Appendix G: Public Information Centre Materials and Public Comments

McCraney Creek Bridge Replacement

Schedule 'B' Municipal Class Environmental Assessment

Comments: Residents

Vertical drop – barrier to fish passage

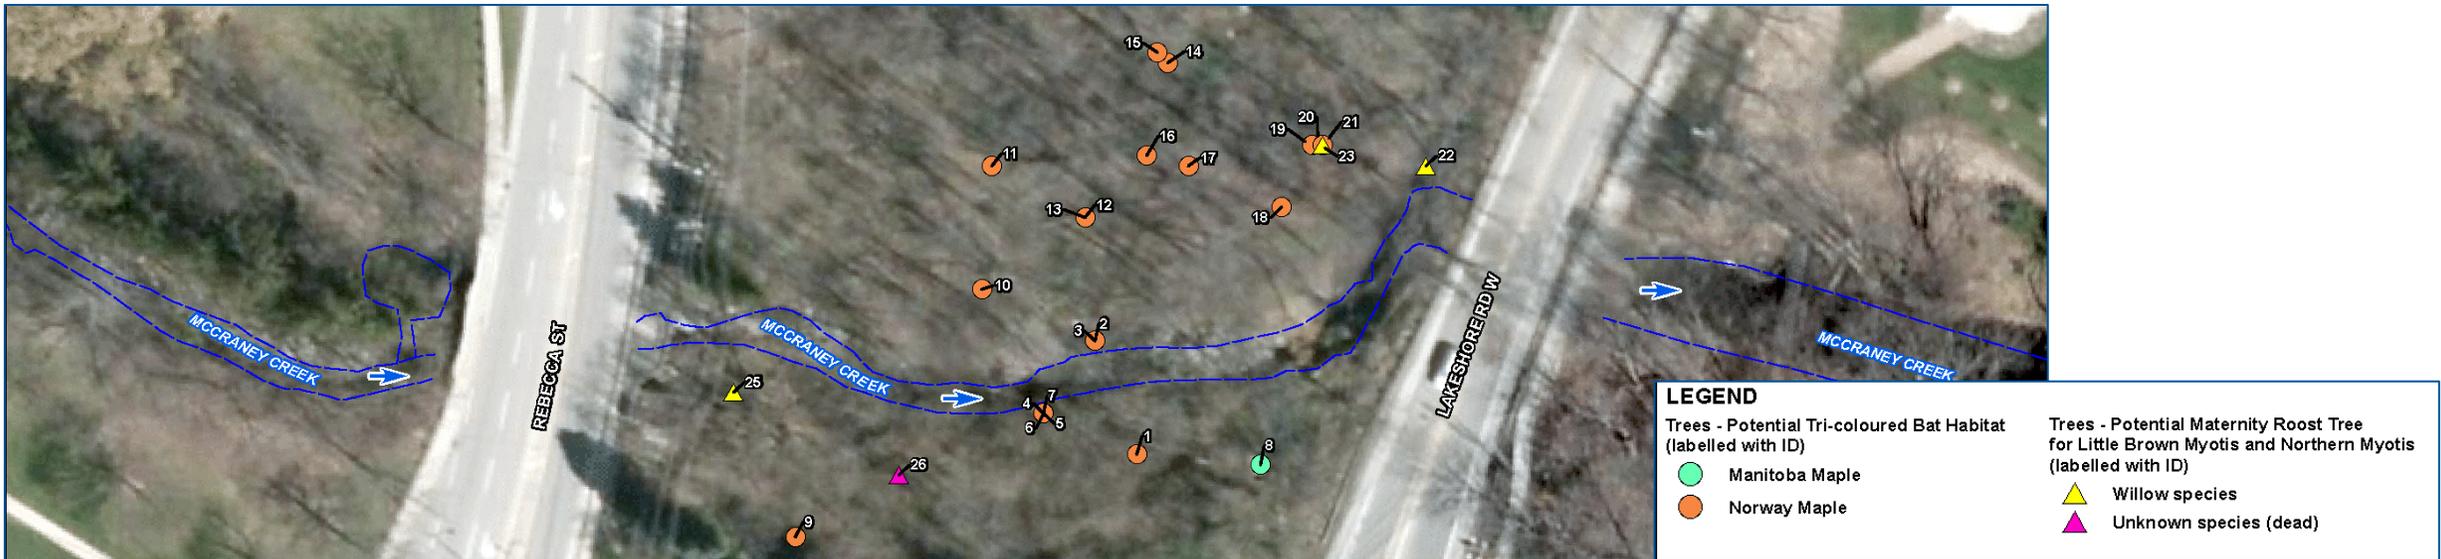
McCraney Creek Bridge Memo

The memo notes: Immediately downstream of Rebecca Street, there is a vertical drop where the poured concrete slab foundation of the crossing meets the natural stream substrate ... The vertical drop from the poured cement slab to the natural stream substrate is approximately 0.5 m high on the west and 0.8 m high on the east.

Question: Will the works undertaken for the bridge correct this problem or is this to be addressed in stream work later? When might that be?

Response: The barrier to fish just downstream of Rebecca Street is formed as a result of the fixed grade of the Rebecca Street crossing's slab foundation. There are currently no plans to remedy this condition as part of the McCraney Creek bridge replacement at Lakeshore Road as channel works are not expected to extend as far upstream as Rebecca Street. The removal of this fish barrier would be considered in the future at the time of infrastructure renewal of the Rebecca Street crossing.

Proposed Bridge Design

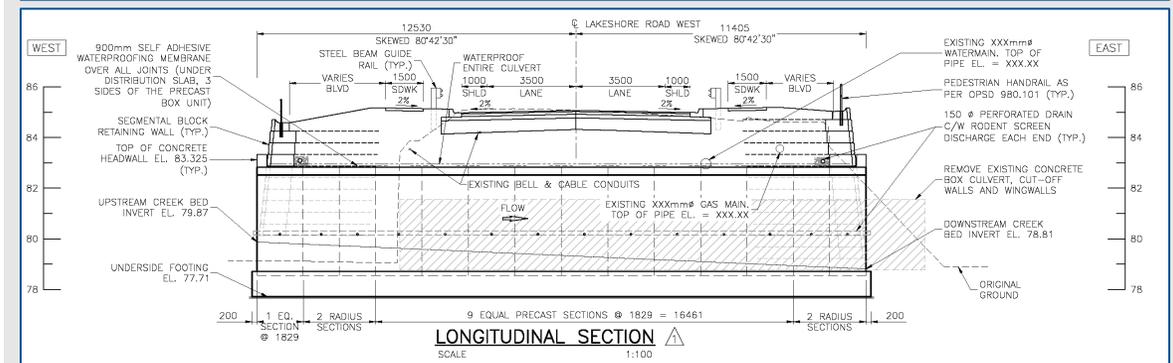
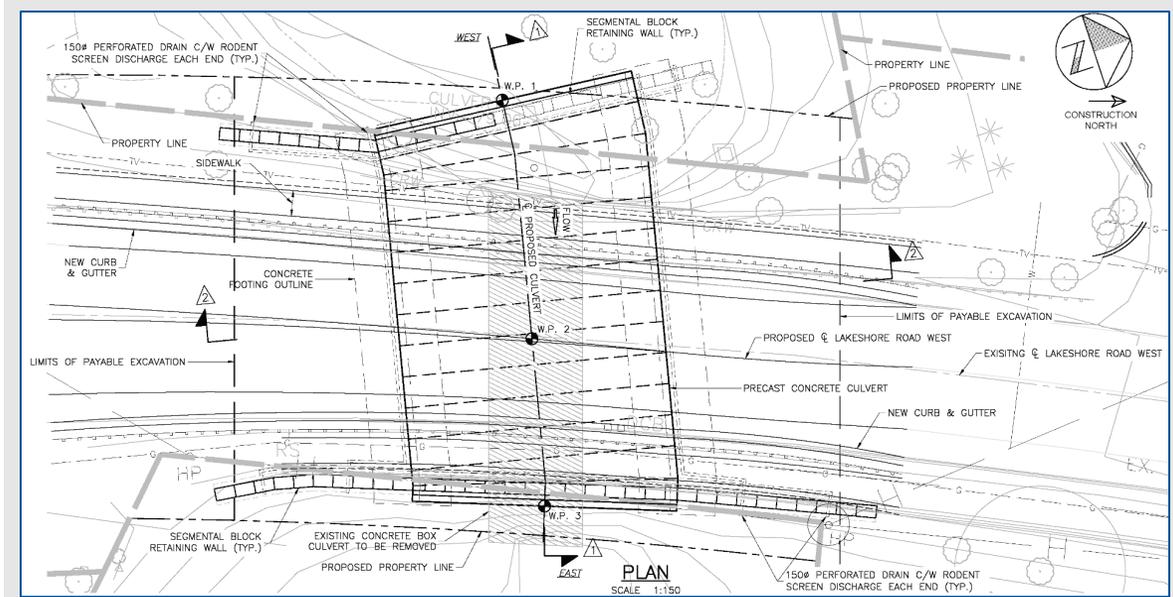
General Arrangement Drawing

Unfortunately, nothing in the EA presentation materials show where the new bridge will be in comparison to the present bridge and its location.

An overlay of this type would be very helpful to provide residents with a better understanding of the project.

How far into the woodlot area will the bridge project? How far into the present stream area?

Is there an incline to the new road surface?

Documents refer to the bridge being 'marginally larger' but there are no dimensions given. Would these please be provided?

Both the Longitudinal Cross Section and the Culvert West Elevation appear to show one of pedestrian sidewalks as being a stepped approach.

Is this correct? Once again, a better illustration of the bridge would be quite helpful.

Response: The existing structure is shown on the general arrangement drawing in gray, and the proposed structure is shown in black. The gray color was used for the existing structure to differentiate it from the proposed structure. The drawing is included in the PIC slides as well. We have updated the drawing so that the existing structure is clearer to the public.

Response: The proposed structure extends to the north by 7.87 metres from the face of the existing structure. We have updated the drawing to show these dimensions.

Response: There is no change in profile of the roadway/bridge deck proposed at this location.

Response: The existing structure is 5.4 metres wide and 20.4 metres long. The proposed structure is 14.64 metres wide and 25.99 metres long on the east side and 21.95 metres long on the west side. We have updated the drawing to show these dimensions.

Response: We would like to clarify that the sidewalks will not be stepped. They will follow parallel to the roadway surface. The step shown on the left side of the west elevation is for the wall only.

Flow issues and barriers to fish movement in McCraney Creek must be remedied as reported in the following excerpt:

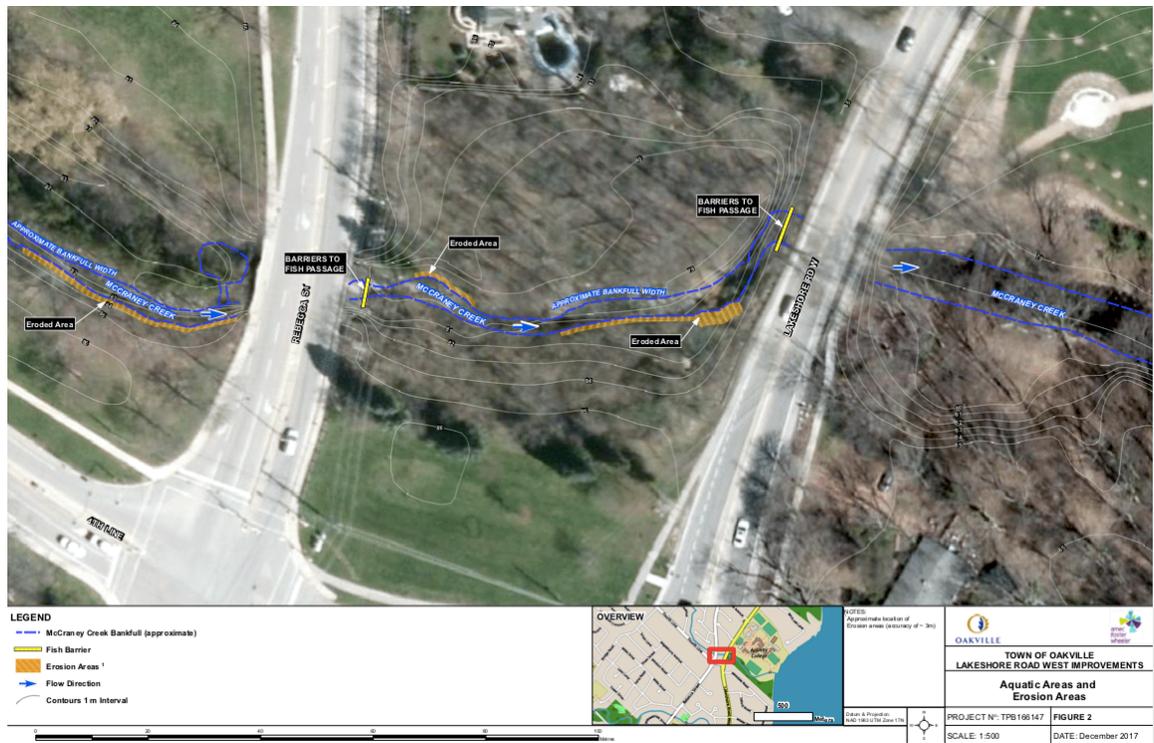
Flow Issues and Barrier to Fish Movement

- The proposed channel design will remove the bedrock barrier in the crossing at Lakeshore Road West to improve fish passage. Stone treatments in the crossing bed will promote small wildlife movement.
